COMPANY / PROJECT
ST185 CELICA GT-FOUR - LINK ECU CONVERSION

TITLE
LOGIC BOX - BASE

PART / DWG NO.	REV	MATERIAL
ST185-FB-105	T	PA12 (SLS / MJF)

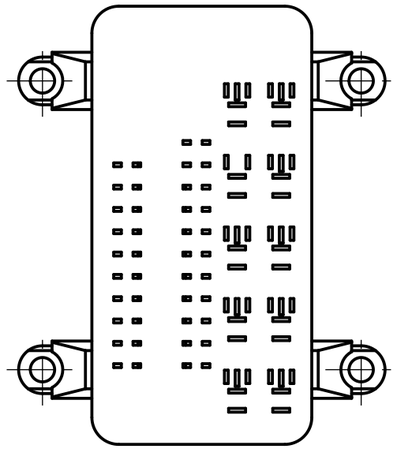
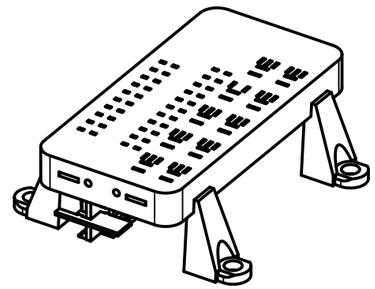
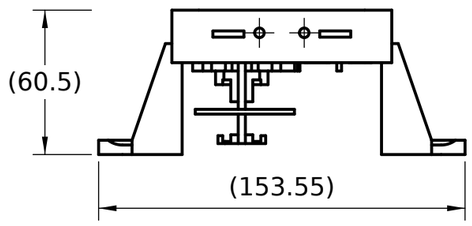
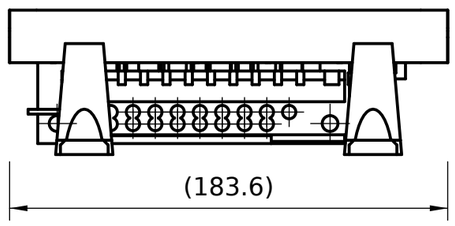
REVISIONS			
REV	DESCRIPTION	BY	DATE
M	Dan's N2 / N3 / N4 answers (#273)	Claude	16/10/26
N	LOGIC Bus 2 x 48.1 corner joint stays solid (sweep fixes) (#275); first drawing issued (#280)	Claude; drawing SteveCAD	17/10/26
P	Dan's markup 17/10/26 (23-21): spare fuse positions deleted, the rest on a 9.35 grid from y 31.7 (jumpers sized by fuse)	Claude	18/10/26
R	Fit audit + N21 18/10/26 (R165, R166): micro relay pattern to TE V23074, sockets 3.2 deep; mini fuse sockets at the real 8.1 pitch with TE MCP 2.8 receptacles; box 3.15 wider; spine 3.0	Claude	18/10/26
S	HEAD relays M1 / M2 get the 87a blade slot (R170, #308): model changed after the R drawing; drawing reissued in the buildability review 18/10/26	Claude	18/10/26
T	Bus strips held on every side by the base: spine pads against each strip, kerb and top lips on the lug face, front stop pads, a rear snap hook per strip	Claude	18/10/26
